UNITED STATES PATENT AND TRADEMARK OFFICE

APPLICATION NO.	FILING DATE	FIRST NAMED INVENTOR	ATTORNEY DOCKET NO.	CONFIRMATION NO.
10/099,775	03/15/2002	Jean-Christophe Jacques Kling	3206.2.1 NP	4985

Office Action Summary

DETAILED ACTION

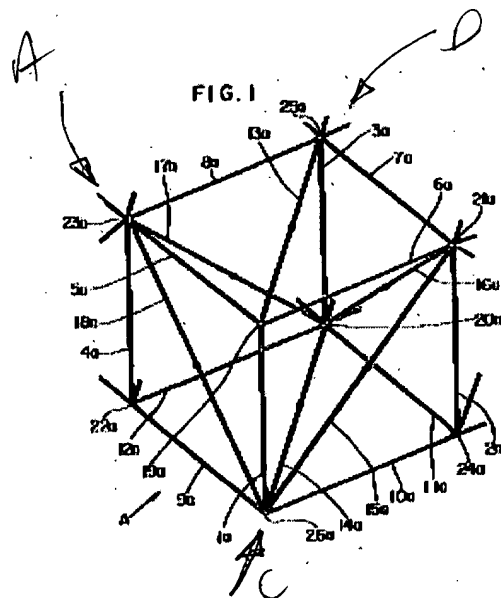
Claims 1-5,7-24 are rejected under 35 U.S.C. 103(a) as being unpatentable over US Patent #4,819,399 to ONODA. ONODA discloses the use of an architectural system including a triangular base (ABC) consisting of a first (17a), second (14a) and third (18a) strut aligned along first (AB), second (BC), and third (CA) axis; such that the first and third struts (17a,18a) form a first acute base angle (CAB), the first and second (17a,14a) struts form a second acute base angle (ABC), and the second and third struts (14a,18a) form a third acute base angle (BCA), see below; wherein the struts

(17a, 14a, 18a) each consist of at least two rigid pieces in that they can be folded (column 8, lines 4-8 and 53-54) and movable apart to form a strut elongation. The structure further includes a first node (A) engaging the first (17a) and third (18a) struts, a second node (B) engaging the first (17a) and second (14a) struts, a third node (C) engaging the second (14a) and third (18a) struts forming the base triangle (ABC) and base plane; and an extension (15a) consisting of a fourth strut aligned along a fourth axis (CD) that does not lie in the base plane of the triangular base (ABC), see the marked attachment. ONODA discloses the basic claimed structure except for explicitly detailing the exact dimensions of the angles forming the base triangle or the angle of the fourth strut. Although ONODA does not detail explicit angles that form the base triangle, it would have been obvious to one having ordinary skill in the art at the time the art was made to select an angle dimension suitable for the use intended as an obvious matter of design choice. For instance, larger width structures a larger angle dimension would be required; however, when a smaller size structure is being formed, a smaller angle dimension would be required. Also, the strength of the member forming the strut
